Access Compliance Report

Public Rights-of-Way

Intersection ID: 29960	Main Street: CANIPE_DR	Cross Street: DAVIS_CROSSING_CT	Location: S
ADA ID: C44E58B7ED39	Ramp Type: Perp	Initial Pass/Fail: Fail	Overall Compliance: No
		Severity Score: 8.75

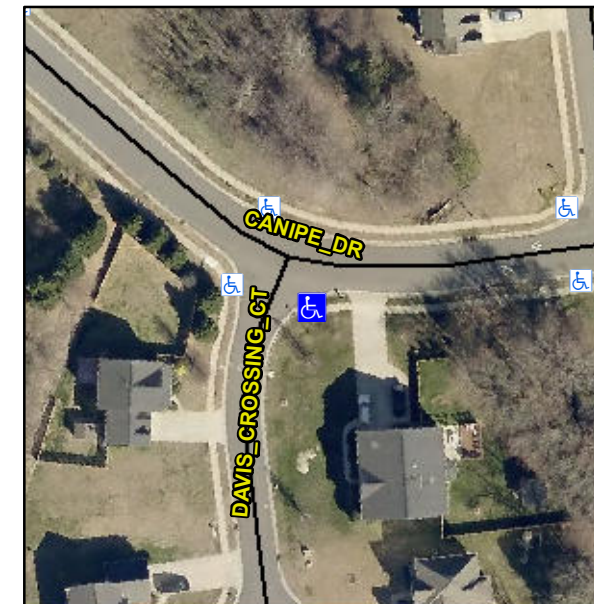
Not Found, R304.5.1

Compliance	Description	Data	Compliance	Description	Data
N/A	Ramp Length (in)	48.0	Yes	Ramp Slope (%)	7.8
No	Ramp Width (in)	40.5	Yes	Ramp XSlope (%)	1.1
N/A	Flare Type LT	N/A	N/A	Flare Type RT	N/A
N/A	Flare Slope LT (%)	N/A	N/A	Flare Slope RT (%)	N/A
N/A	Flare Traversable LT?	N/A	N/A	Flare Traversable RT?	N/A
N/A	Landing Length (in)	N/A	N/A	DWS Provided?	N/A
N/A	Landing Width (in)	N/A	N/A	DWS Contrast?	N/A
N/A	Landing Slope (%)	N/A	N/A	DWS Length (in)	N/A
N/A	Landing X Slope (%)	N/A	N/A	DWS Full Width?	N/A
N/A	Landing Curb? (Y/N)	N/A	N/A	DWS Offset (in)	N/A
N/A	Shared Landing?	N/A			
N/A	Gutter Ponding?	N/A	N/A	Gutter Slope (%)	N/A
N/A	Gutter Lip Ht (in)	N/A	N/A	Gutter X Slope (%)	N/A
N/A	Painted X Walk1?	No	N/A	Painted X Walk2?	N/A
	X Walk 1 Direction	To NW		X Walk 2 Direction	N/A
N/A	X Walk 1 Width (in)	N/A	N/A	X Walk 2 Width (in)	N/A
	X Walk 1 Slope (%)	2.3		X Walk 2 Slope (%)	N/A
	X Walk 1 X Slope (%)	4.1		X Walk 2 X Slope (%)	N/A

Remove & Replace Entire Ramp.
